The following information supplements and/or supersedes the bid documents dated: 2013-07-05

RCMP
OFFICE RENOVATIONS

MAIN FLOOR REVISIONS

SK-M-01

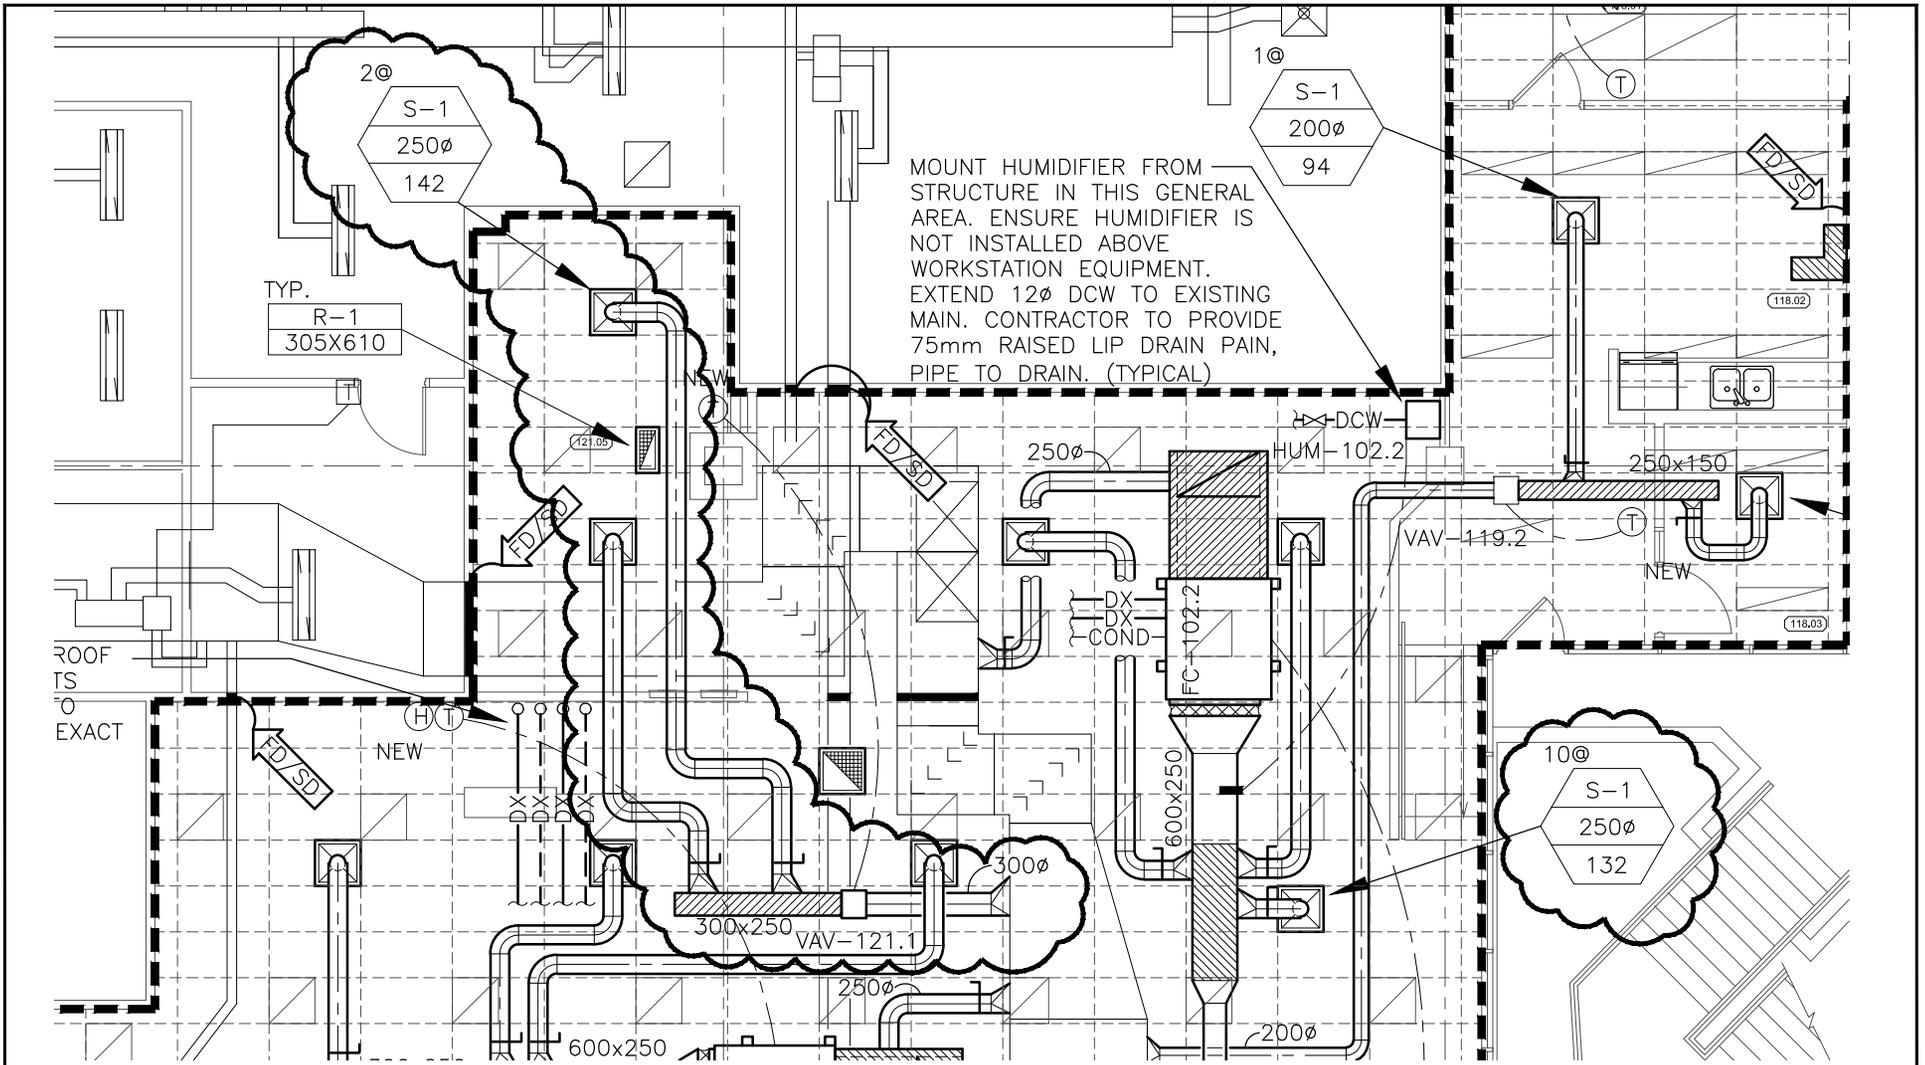
MECHANICAL																
	DRAWINGS															
1.1	<p>Refer to attached sketch SK-M-01</p> <ul style="list-style-type: none">- Re-balance diffusers serving DOCC Room 102.03 from 151 l/s to 132 l/s.- Re-size ductwork serving VAV-121.1 as shown.- Re-balance diffusers serving Break Room 121.05 from 47 l/s to 142 l/s. <p>Refer to attached sketch SK-M-02:</p> <ul style="list-style-type: none">- Change the existing Fan coil units FC-102.1, 102.2 and condensing units CU-102.1, 102.2 specified to the new units specified in the sketch. <p>Refer to Drawing M1.1:</p> <ul style="list-style-type: none">- Refer to VAV box Schedule:- Revise VAV-121.1 from a size 150Ø to a size 200Ø with a maximum air flow rate of 283 l/s. <p>Include the following Fan coil schedule to be read in conjunction with drawing M1.1:</p>
